Bryton – Lot 2 Outparcels Sketch Plan

PART 1: PROJECT SUMMARY

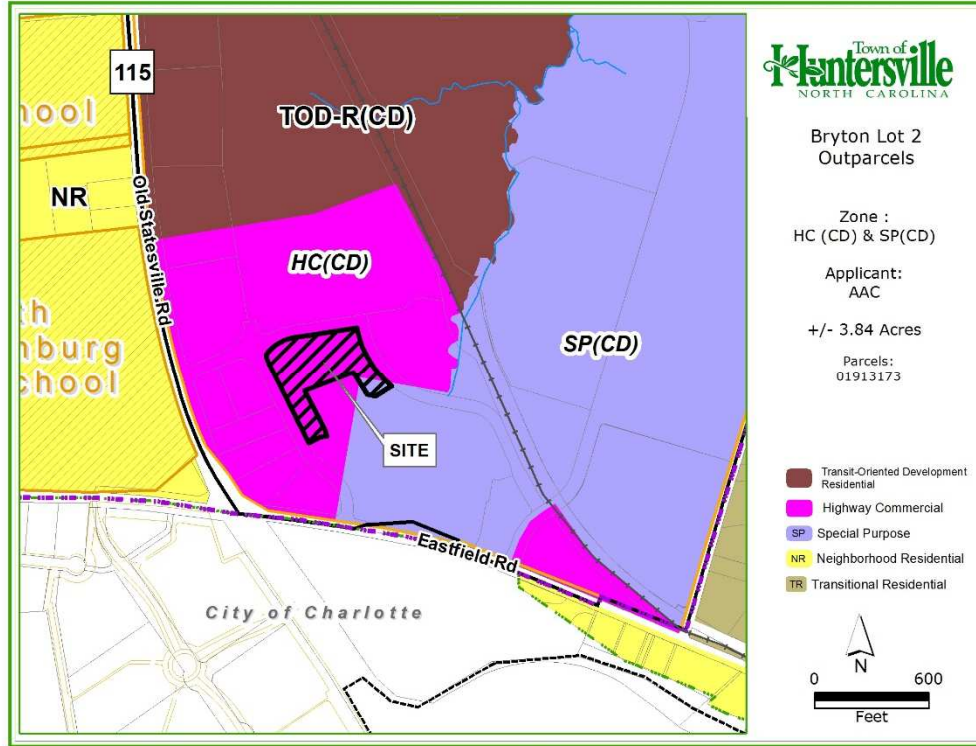
- Buildings on Lots 2-D & 2-E need to address the intersection. Staff discussing options with applicant on building placement, which can be decided at Preliminary Plan review.
- Provide “Willingness to Serve” letter from Charlotte Water.
- Minor comments to the notes of the site plan
